Doc.No. 5207-005000A Date: 200617 Approved by: PL

Change No. 19909

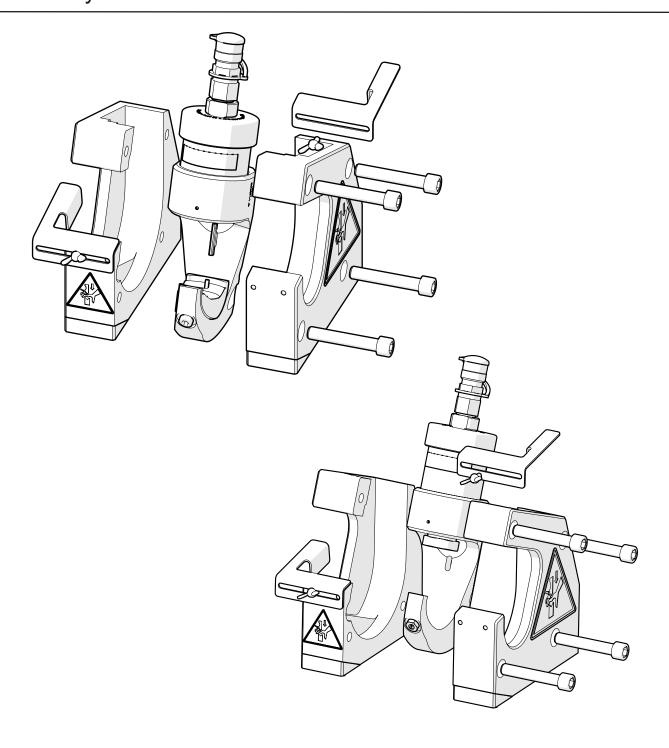
To make the security test the tablestand need to be removed. That is easily done by just loosen the screws.

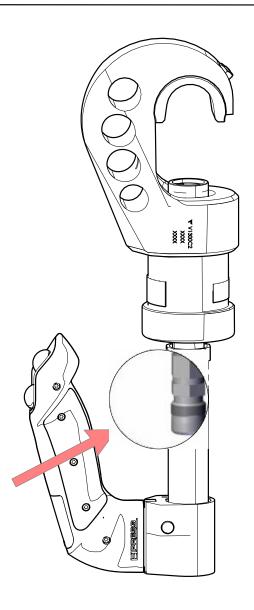
Risk for oil leakage in the quick coupling, see the area the arrow shows. It's is very important that the Ergo pipe is not loosen and it has it's original position to prevent sudden oil leakage.
